ENVIRONMENTAL REVIEW TEAM REPORT

PROPOSED CEMETERY, DIOCESE OF BRIDGEPORT
STAMFORD, CONNECTICUT

FEBRUARY 1981

FIGURE 2.
SIMPLIFIED SITE PLAN

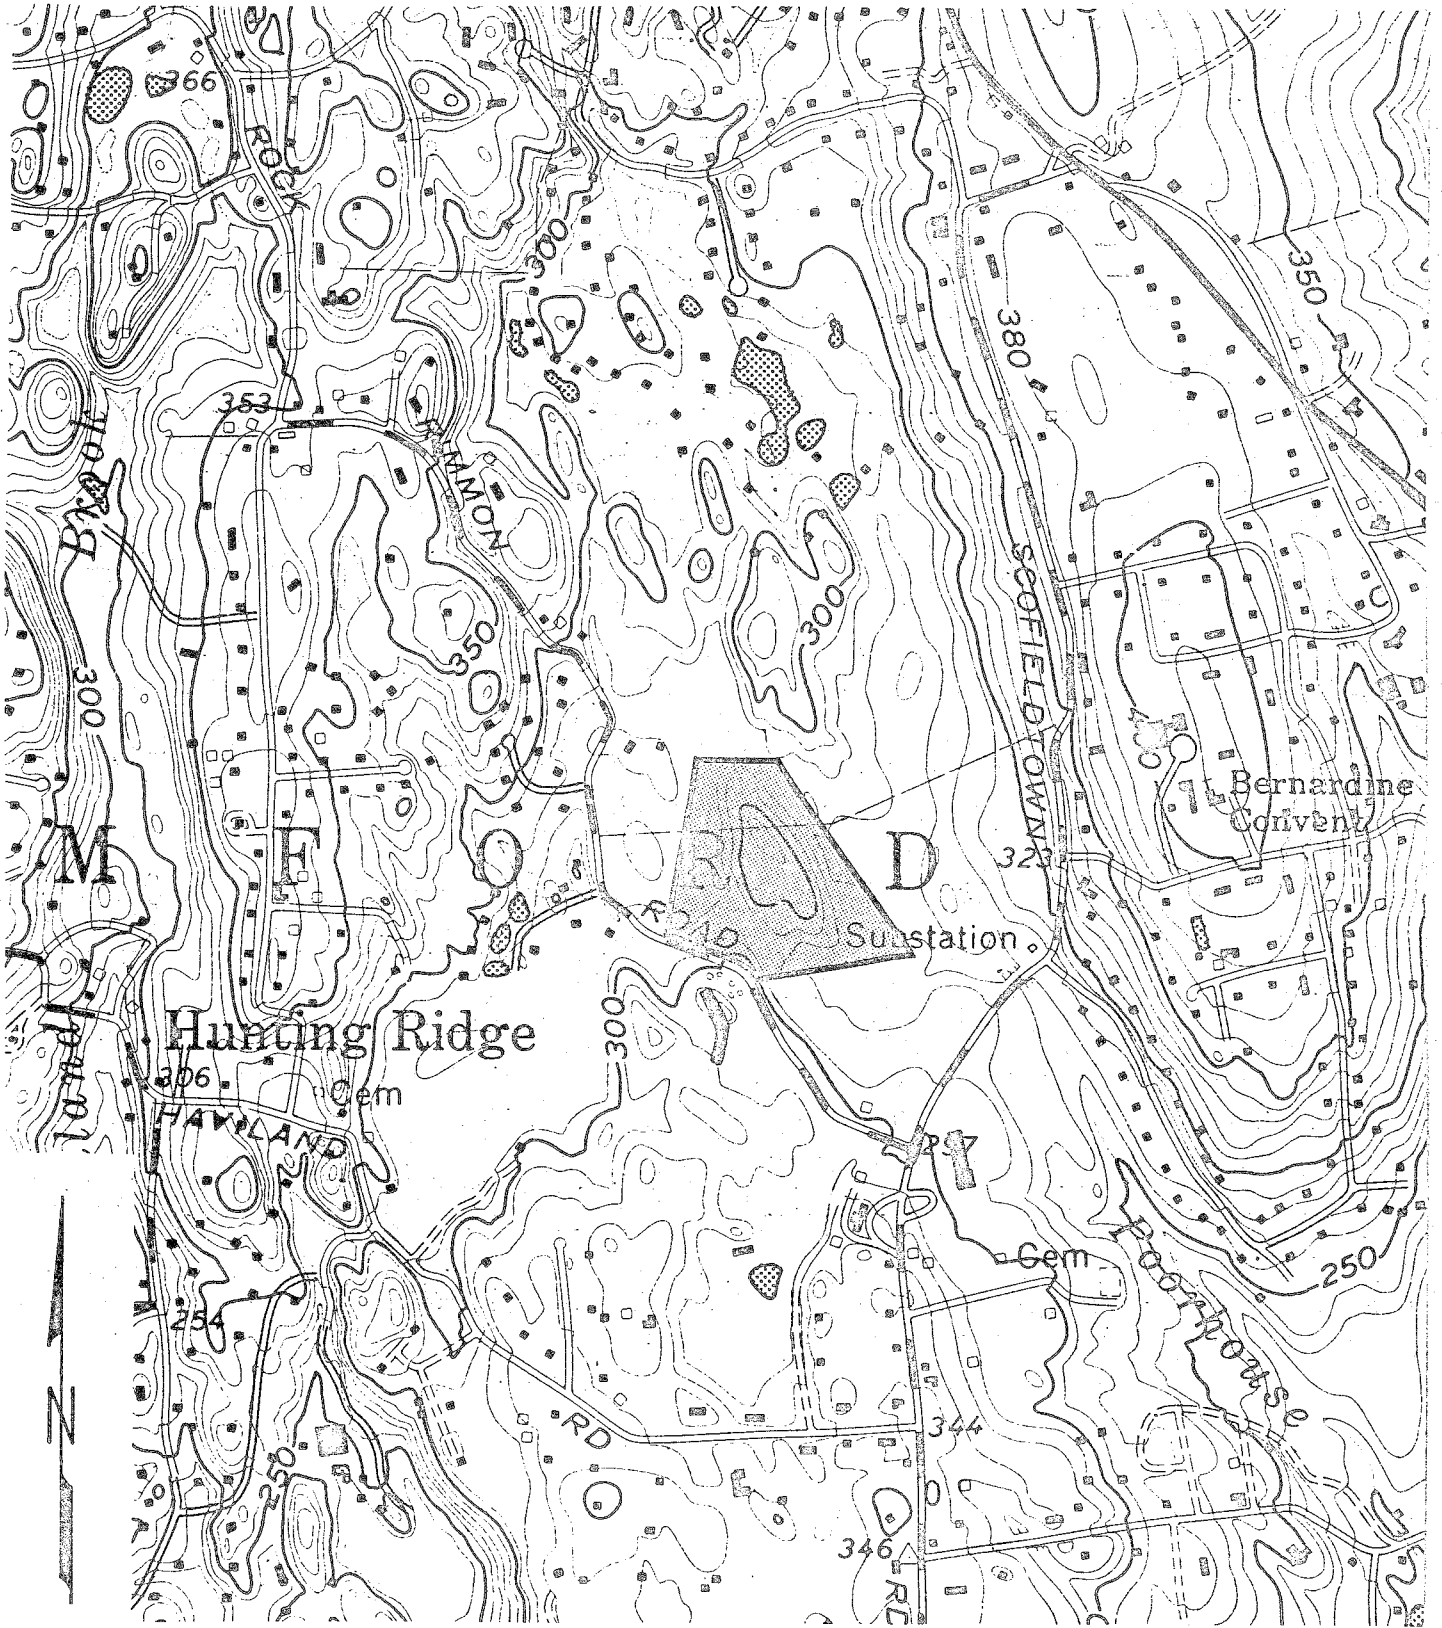
Long-range plans for the site include the development of an office and chapel. Subsurface sewage disposal facilities would be required. Plans for the property presently show the future septic system as being located near the cemetery entrance along Rock Rimmon Road (See Figure 2). Soil mapping indicates that a Charlton very stony fine sandy loam is present in that area. Texturally, this soil is suitable for septic systems, although the presence of numerous large stones may be a technical nuisance during installation. Major constraints may be the slope and the potential for a relatively shallow water table, especially at the western end. At this time, it is possible to say that a septic system in the proposed location seems feasible but that it may require careful engineering to overcome the slope and possibly high water-table limitations. More detailed soil testing and evaluation will, of course, be required before final plans for the office and chapel are presented.

FIGURE 4.
SURFACE WATER FLOW DIRECTIONS

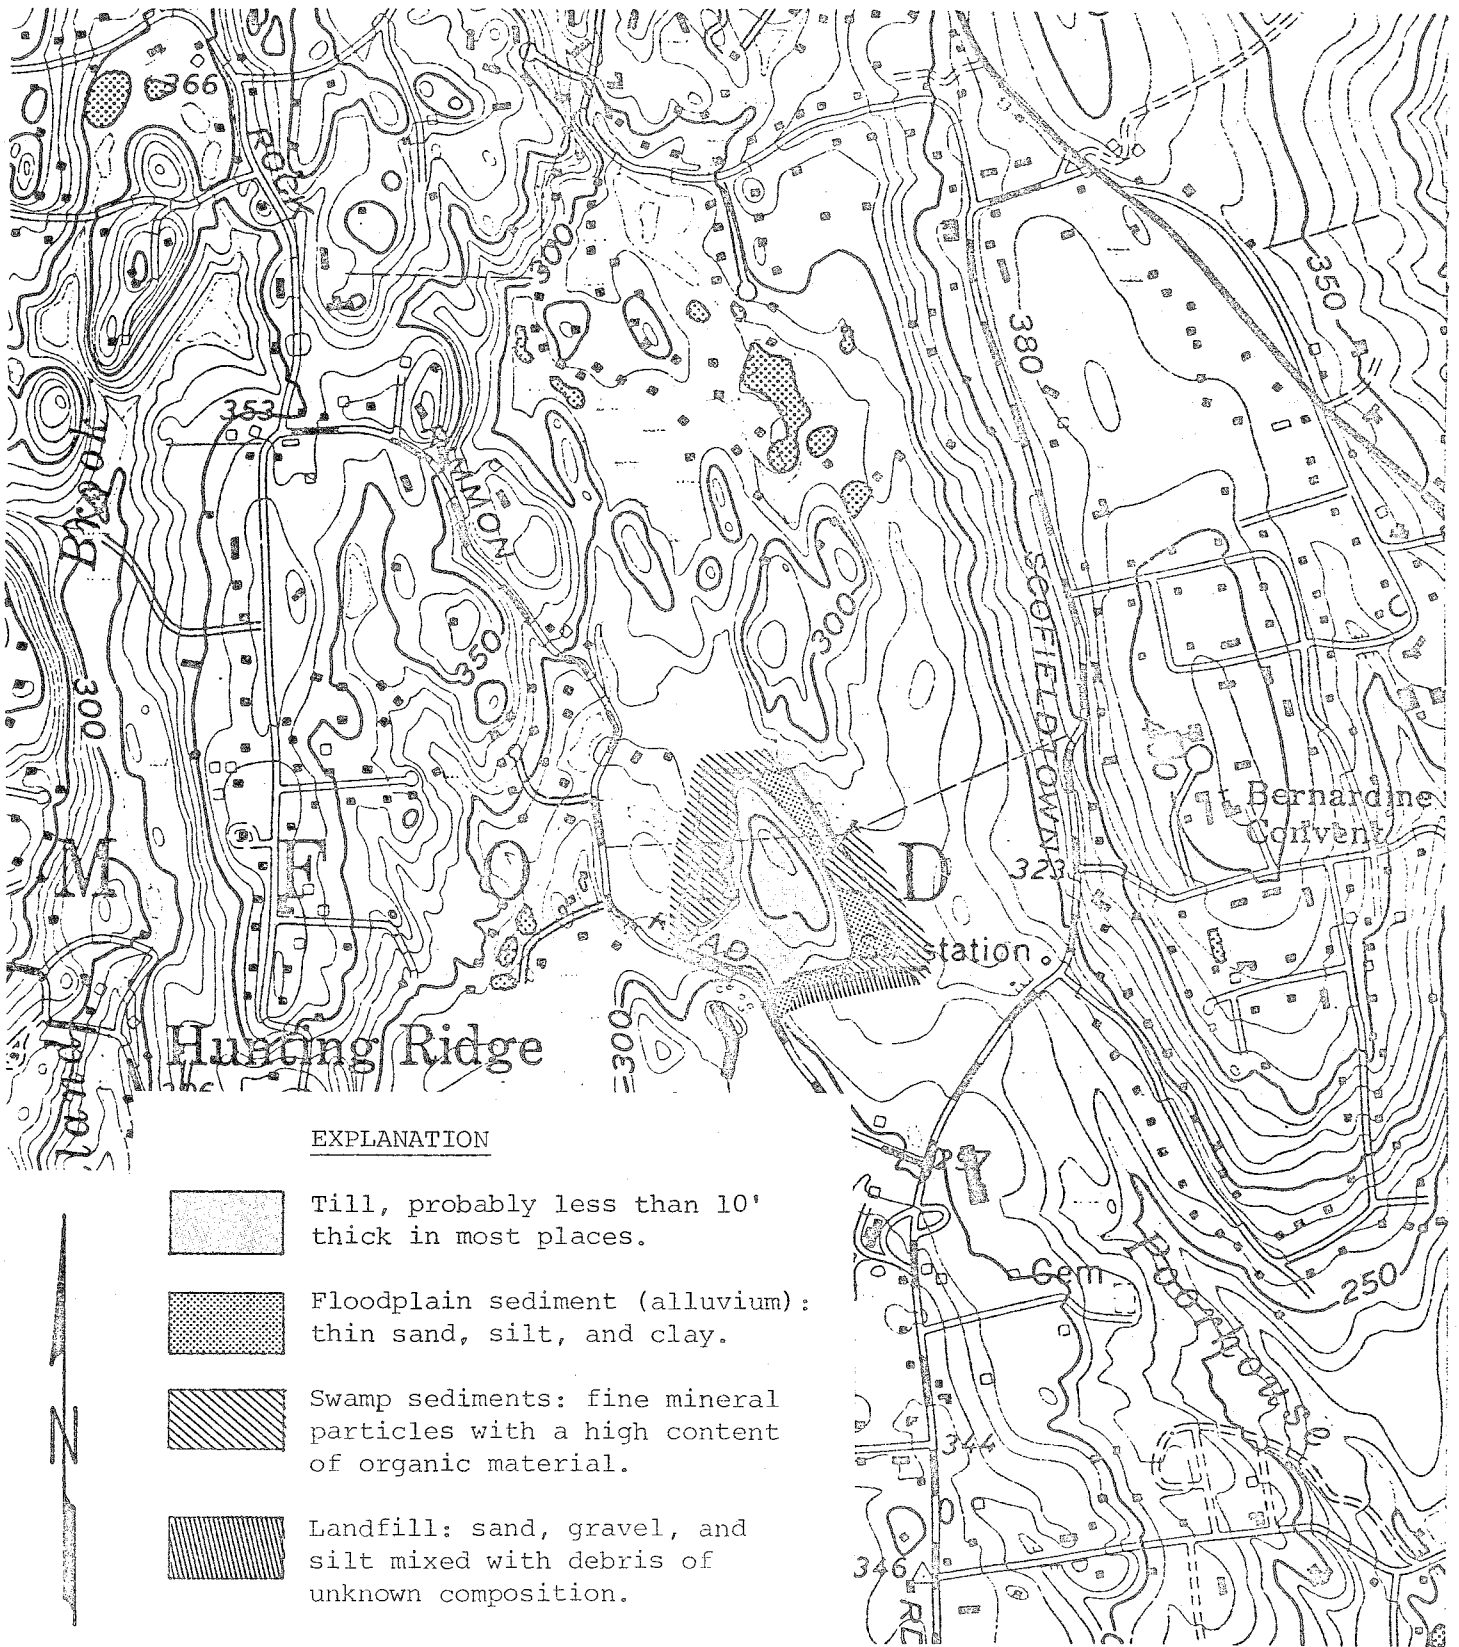
The parcel may be regarded as a near-island surrounded by a "moat". The "moat" is really a complex hydrologic system of swamps and long and short stream channels. Streamflow directions are shown in Figure 4. All surface drainage ultimately flows into a stream (Poorhouse Brook) at the eastern edge of the site. The total watershed of the stream at a point near the southeastern corner of the property is approximately 750 acres. In contrast, the total developed area under the proposal would be less than 10 acres. The effect of any runoff increases generated by the cemetery development would therefore be negligible as regards peak flow rates of Poorhouse Brook. In addition, the developer's consultants have submitted plans for a storm drainage system that would mitigate runoff and flow increases from the site itself. The plans include a retention pond for one section of the cemetery. The "pond" would actually be dry except during periods of precipitation at which time it would collect runoff from most of the eastern half

of the cemetery, including roof drainage from the mausoleum. The pond is designed for a 25-year-frequency storm. The Team geohydrologist believes that, with all things considered, runoff and peak flow increases should not be a major consideration if the proposed drainage system is adopted.

FIGURE 5.

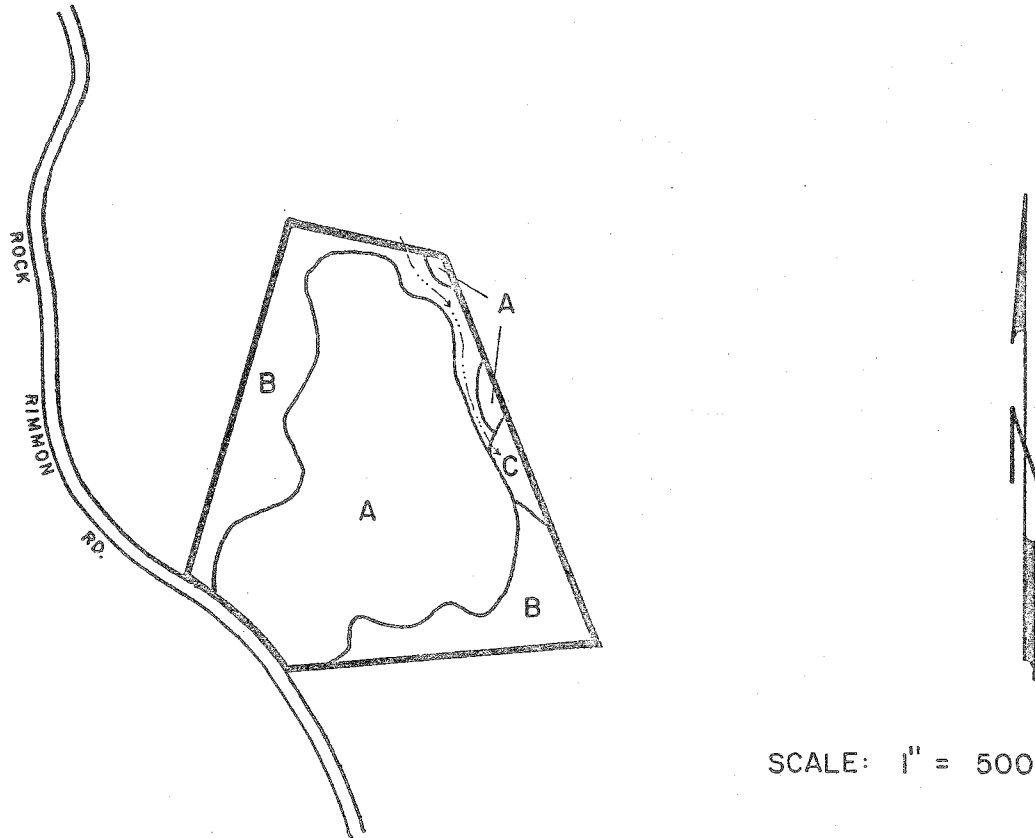
The property proposed for development into the Diocese of Bridgeport's Cemetery may be divided into three vegetation types. These include mixed hardwoods, 12+ acres; hardwood swamps, 6+ acres; and open swamp, 1/2 + acres (see Figure 5 and the vegetation type descriptions below).

The proposed development of this tract calls for clearing and grading approximately 67% of the mixed hardwood stand (vegetation type A). Located throughout this stand are several large healthy trees which would make ideal specimen trees. These trees have extremely high aesthetic and shade value. Many of these trees were marked for retention prior to the ERT field investigation. They should be worked into the landscape plan for this proposal.
